**BULLETIN # B-51-2007-S**

**Subject: Half Size Electric Moisture Plus Convection Oven Water  
Regulator Change part # 4518124**  
**Models Affected: MPOE5L ½ size electric convection ovens**  
**Tim Hortons locations only**

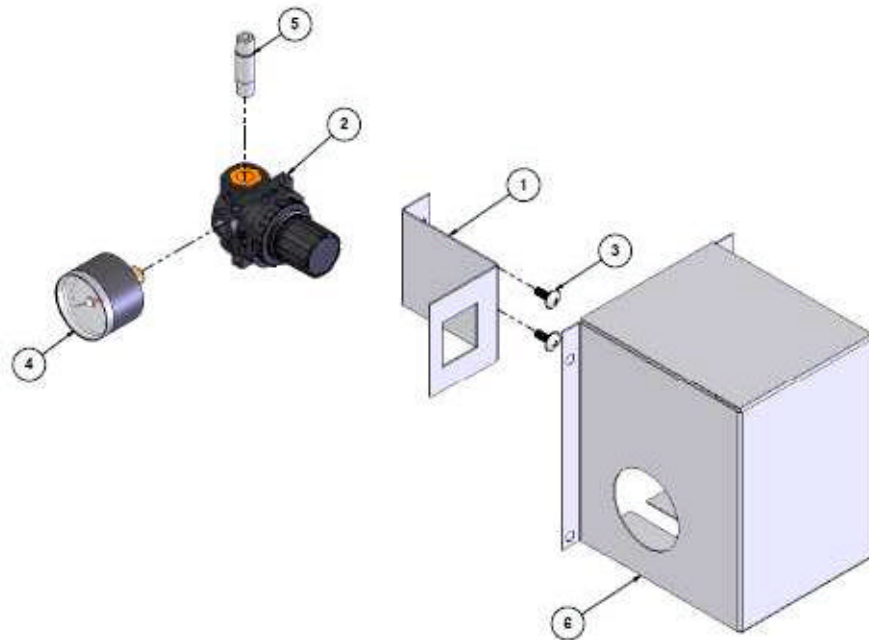
Starting serial number 0704100235307 ( 07 = 2007 04 = April ) the water regulator on the MPOE5L convection oven for Tim Hortons changed.

Units manufactured prior to above serial # were supplied with an AIRTROL water regulator. You can easily identify units with the AIRTROL as ones that do not have a pressure-indicating gauge.

Original AIRTROL regulator part # 4518124 is no longer used in the MPOE5L for Tim Hortons. Kit part # 4522822 will be required if the AIRTROL regulator fails.

When ordering replacement pressure regulators, please make note as to whether an AIRTROL or ASCO valve is in the unit. If an AIRTROL regulator complete kit part # 4522822 is required. If an ASCO regulator, only order parts that are required to complete the service call, as the complete kit would not be required.
